## SERVICE BULLETIN 00023 - REV 1

**Subject:** WD-1221 Engine Mount Standoff inspection/replacement

**Affected Models:** RV-12/12iS

**FIGURE 1:** WD-1221 CRACK LOCATIONS

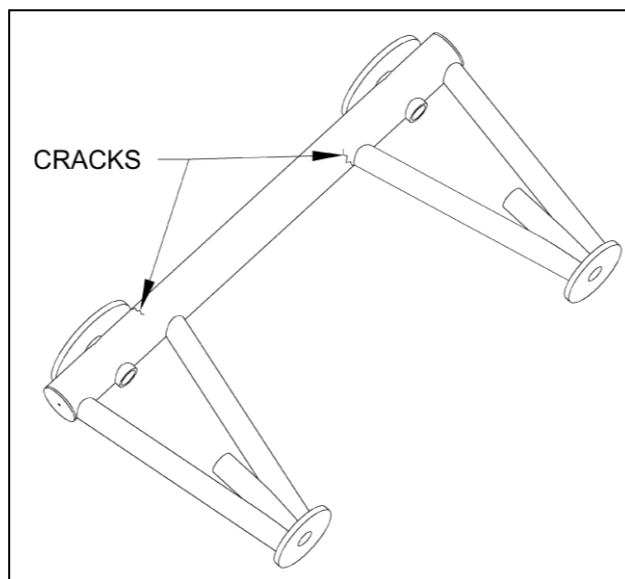
Remove the top cowl. Inspect the WD-1221 Engine Mount Standoff for cracks in the main cross tube (refer to Figure 1 for specific location).

If cracks are discovered in the standoff, notify Van's Aircraft support at [support@vansaircraft.com](mailto:support@vansaircraft.com) and replace it with a WD-01221-1 Engine Mount Standoff as described in this document. If no cracks are discovered, 100-hour inspections are required until the standoff is replaced.

Step 1: Remove the top engine cowling. Inspect the WD-1221 Engine Mount Standoff for cracks at the locations indicated in Figure 1, above. If no cracks are found, log the inspection (as per Step 9 below) and reinspect every 100 hours until such time as the WD-1221 has been replaced per the below steps.
